PGP Steering Committee Meeting  
October 6, 2020 2:00pm  
ZOOM

Minutes

**Vermont Sidewalk Expansion Plans - (Part of the 17<sup>th</sup> Street Module)**

# Potrero Gateway Park

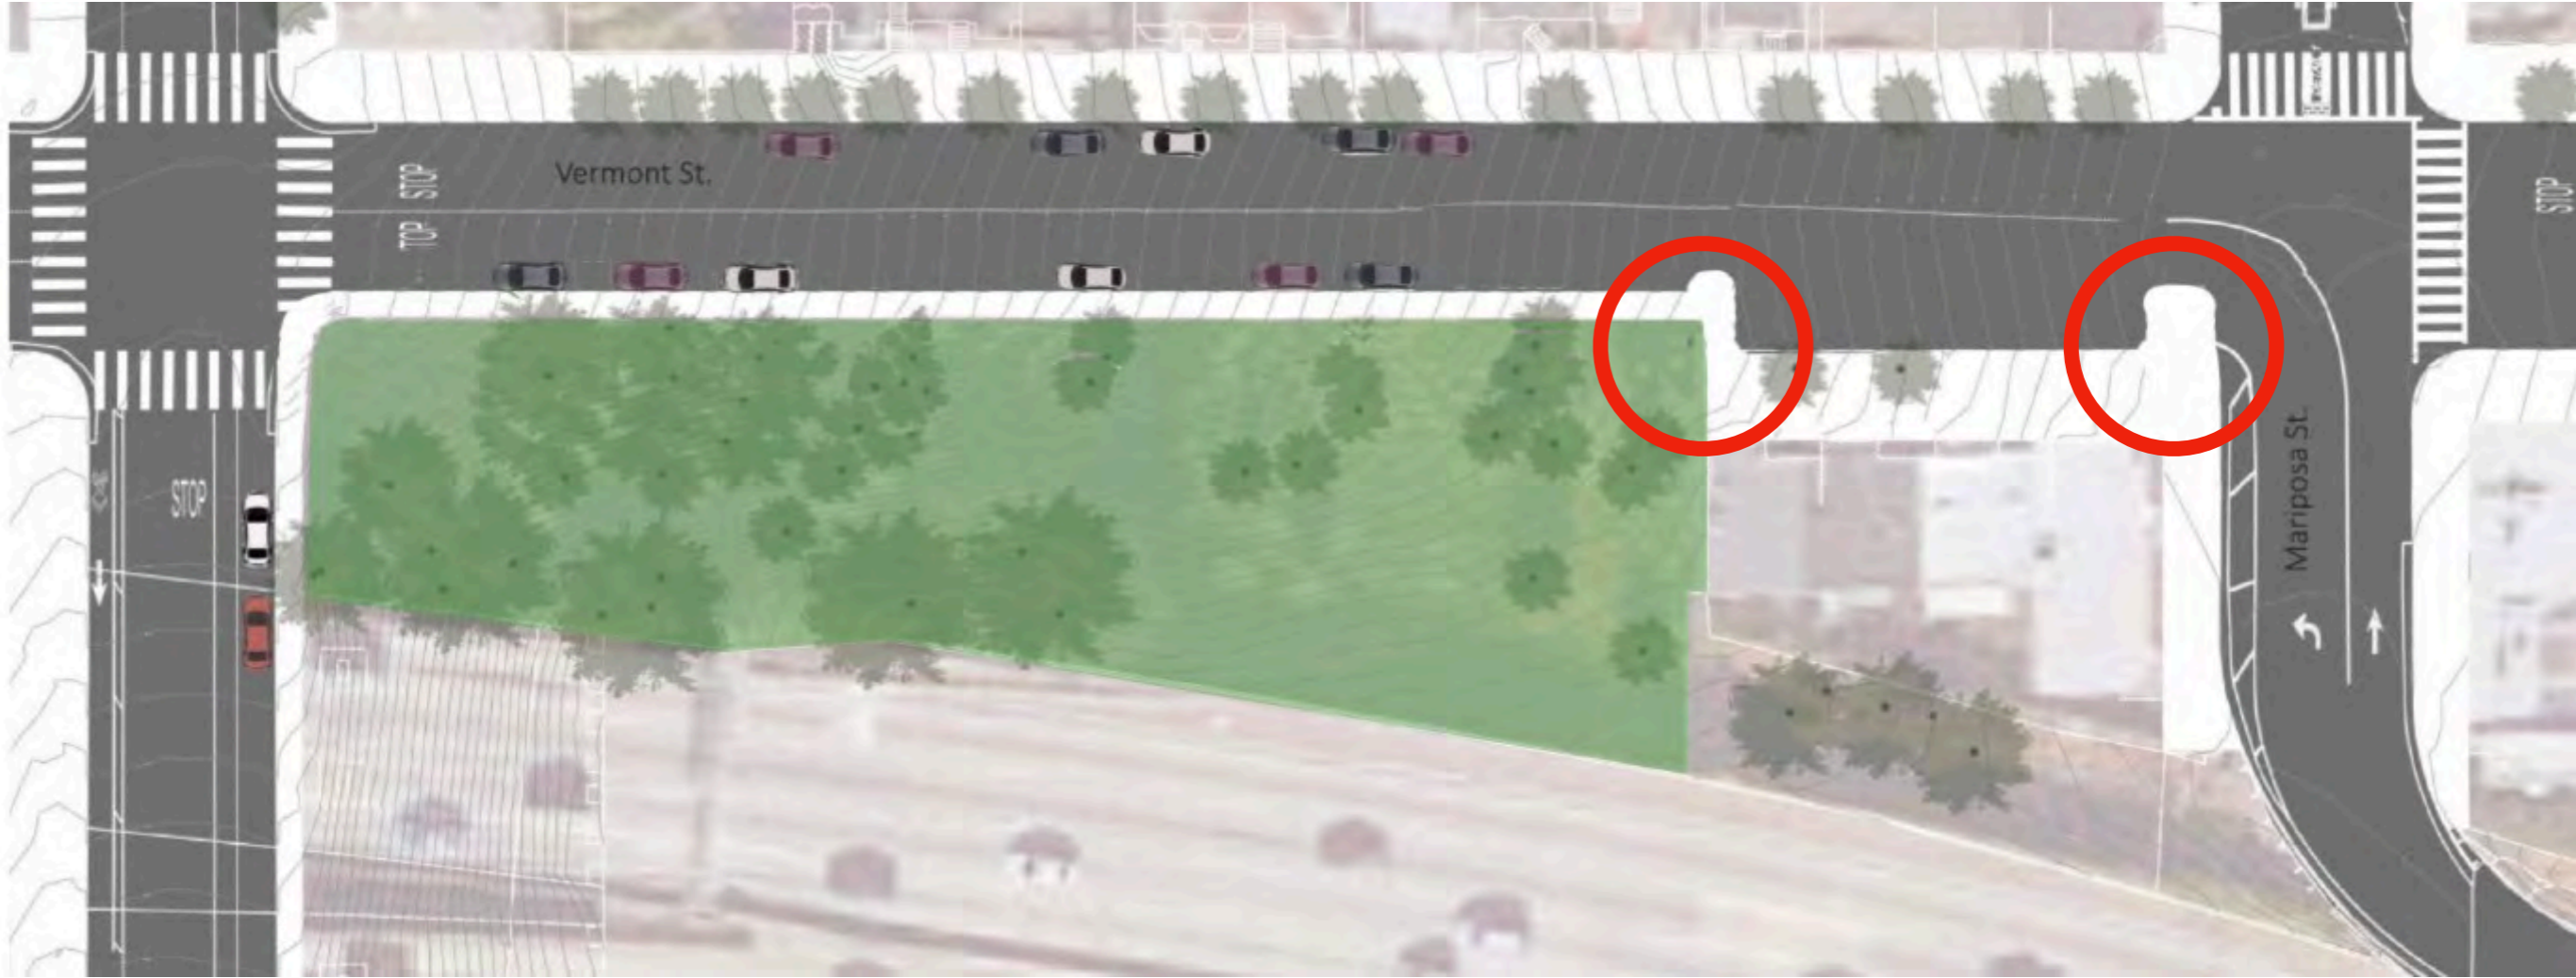
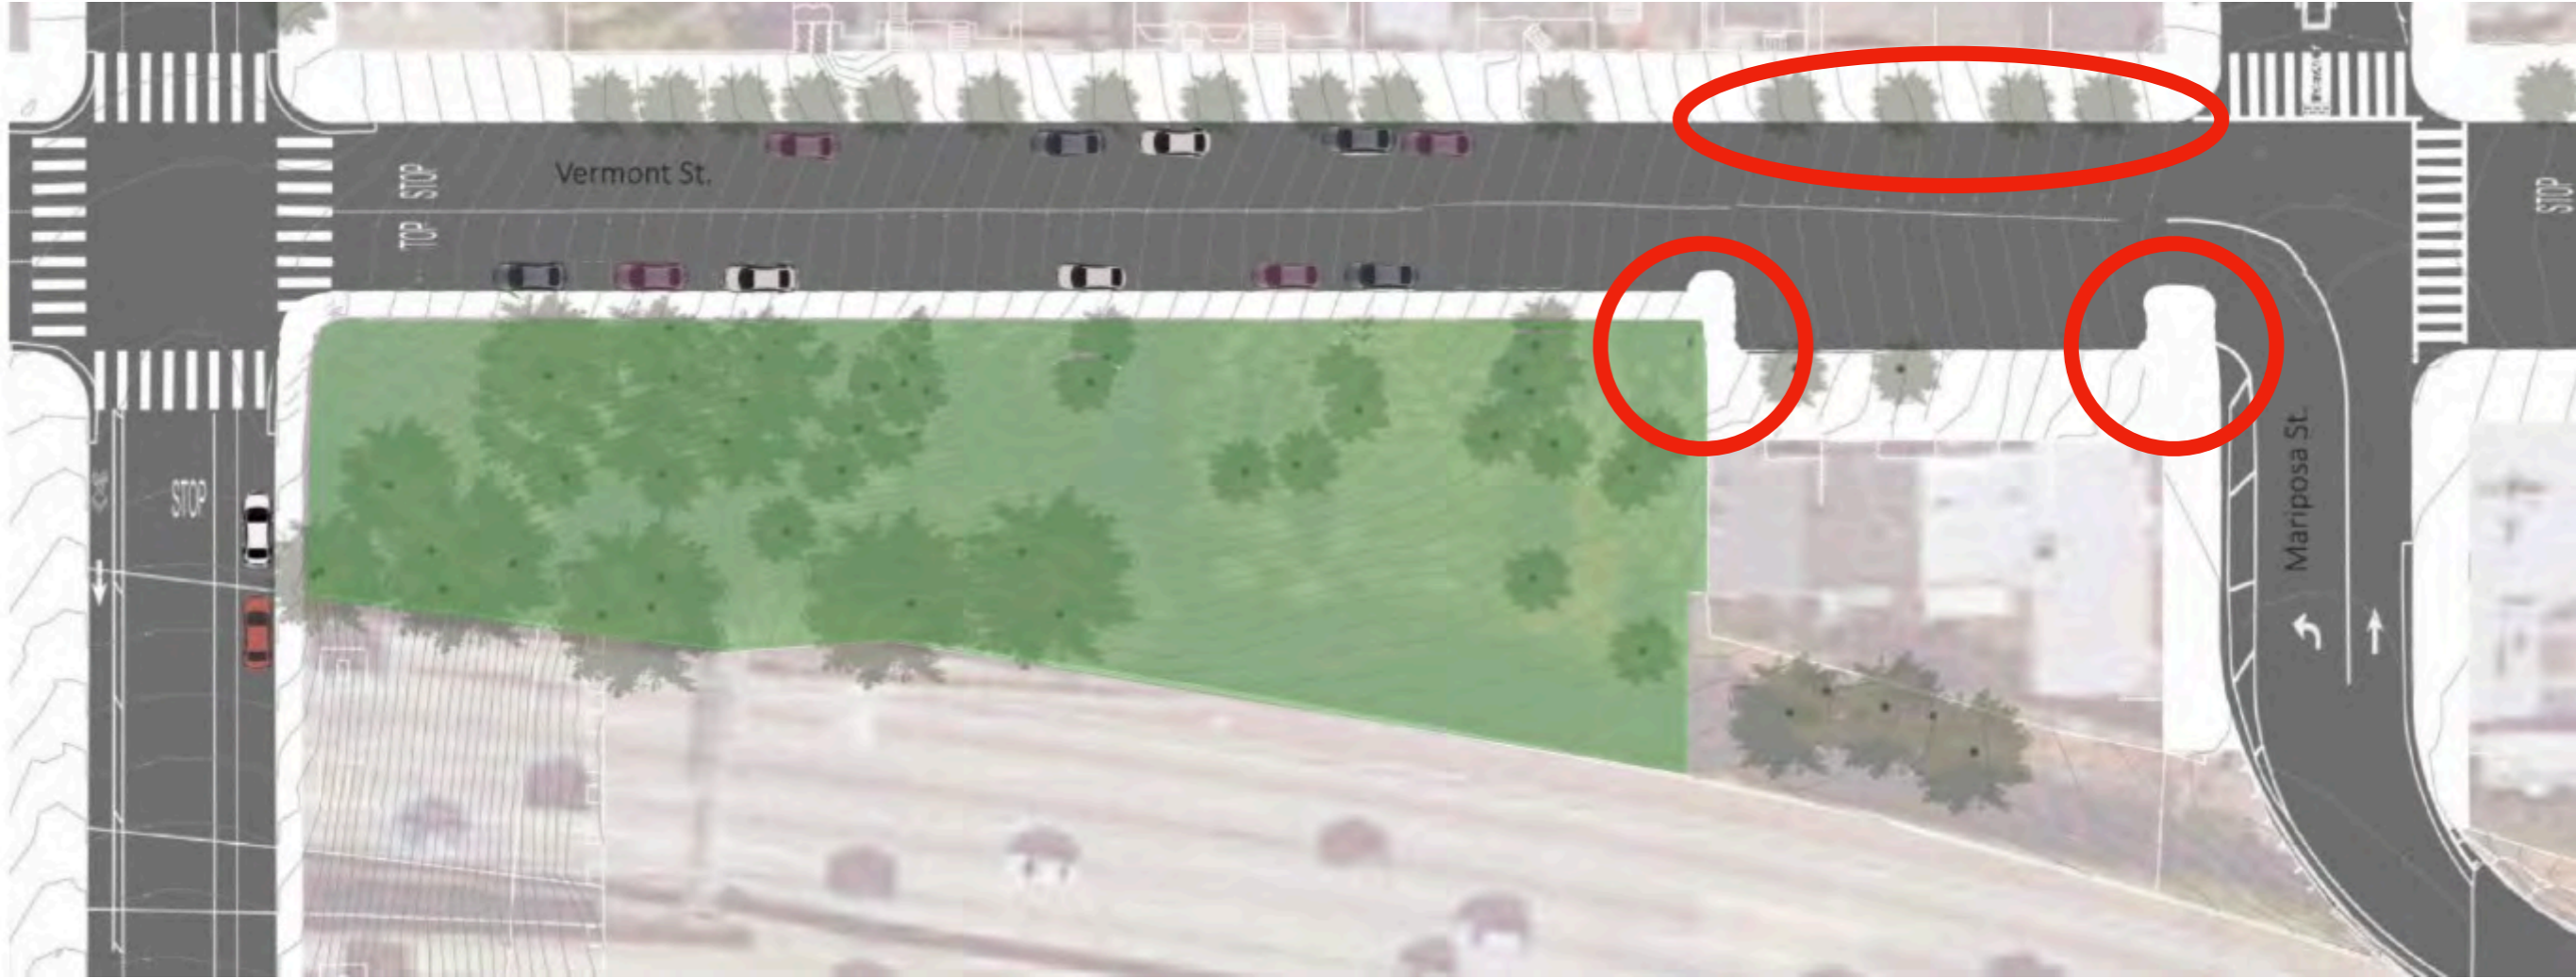
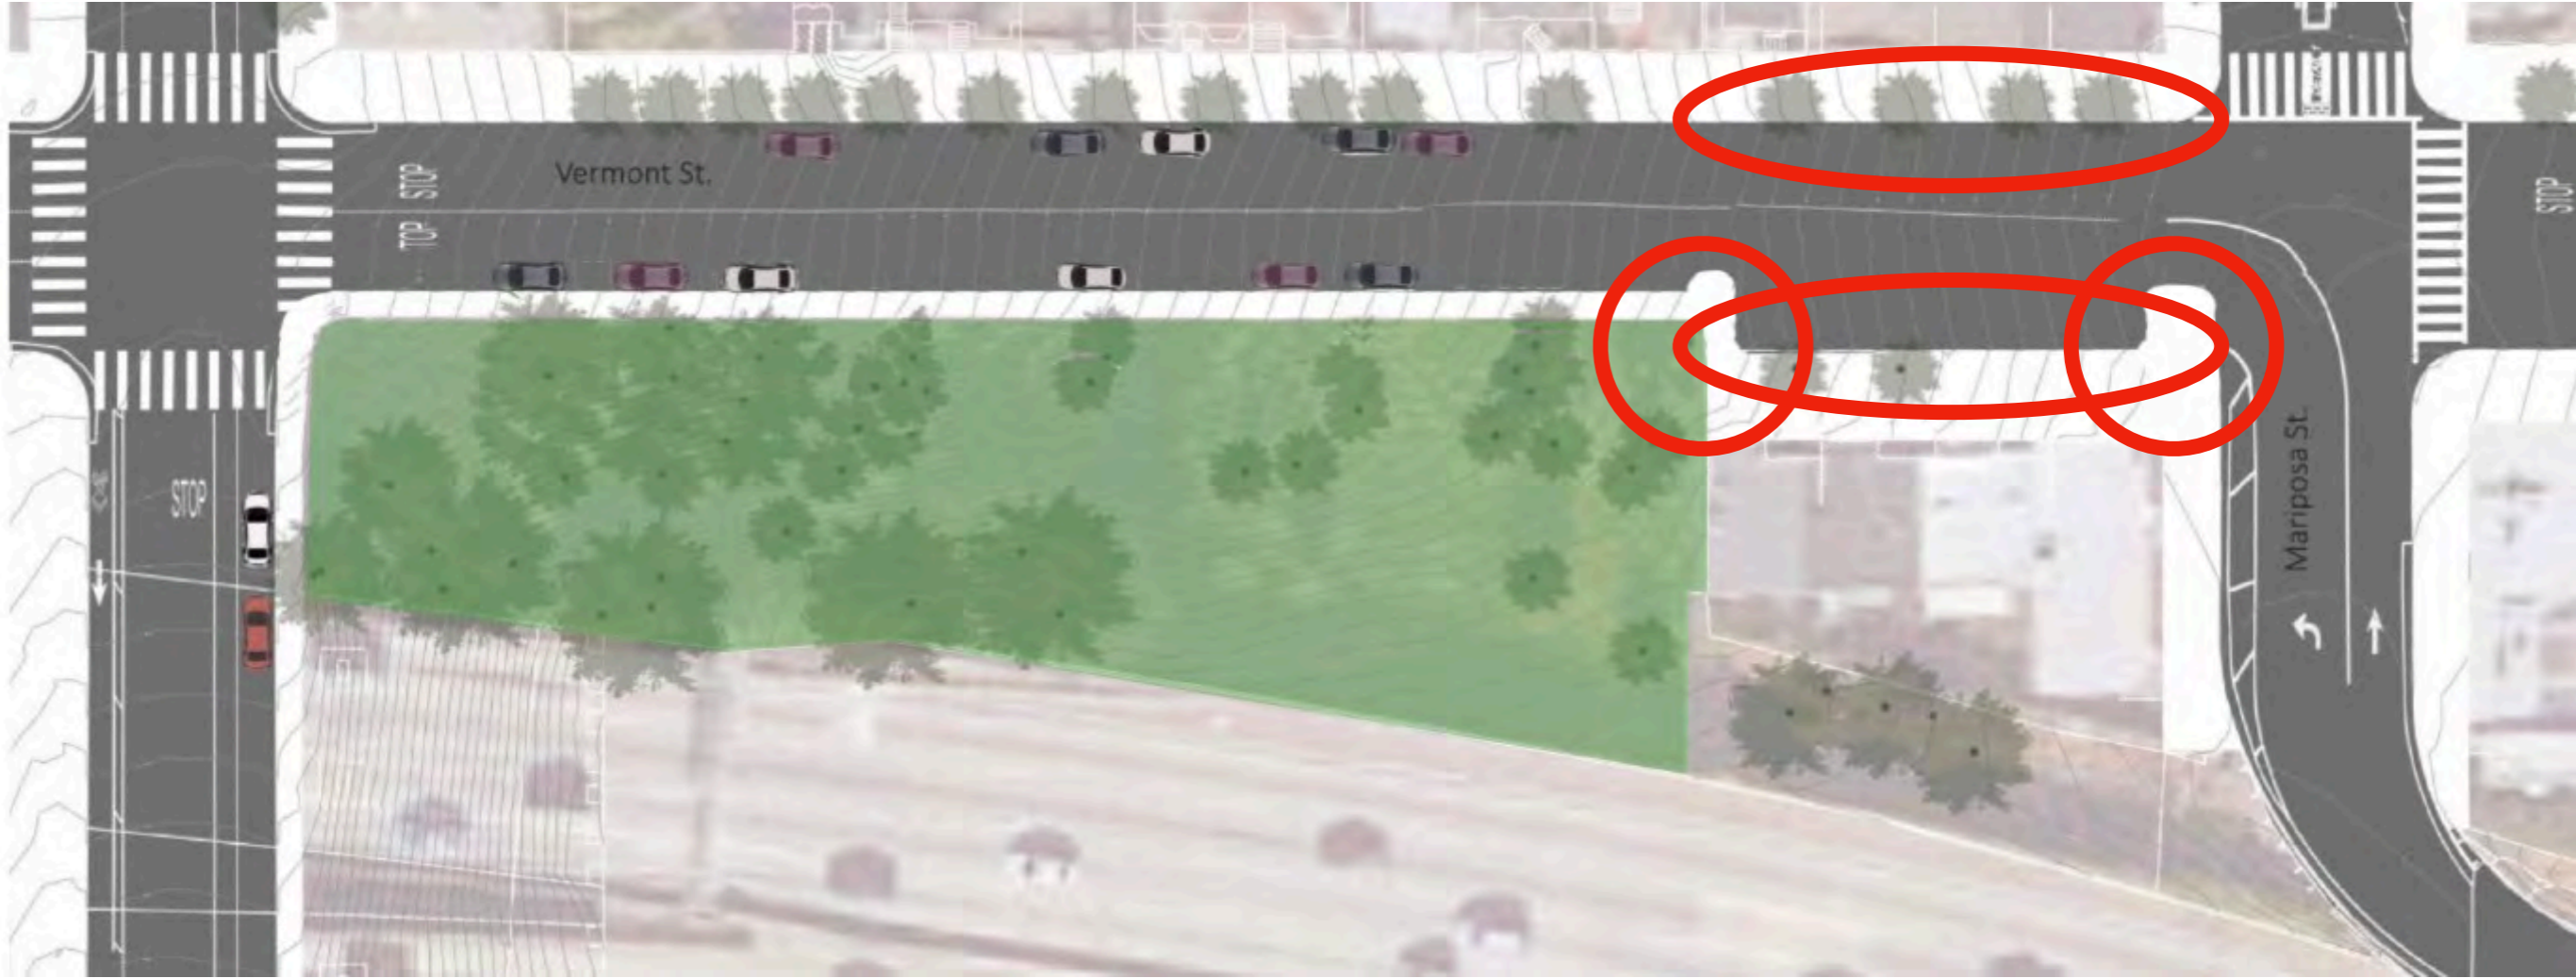
Minnesota Grove is only 36' wide

Vermont neighbors' #1 concern - traffic speed & accidents

Channel traffic to appropriate lanes

Channel traffic away from parked cars
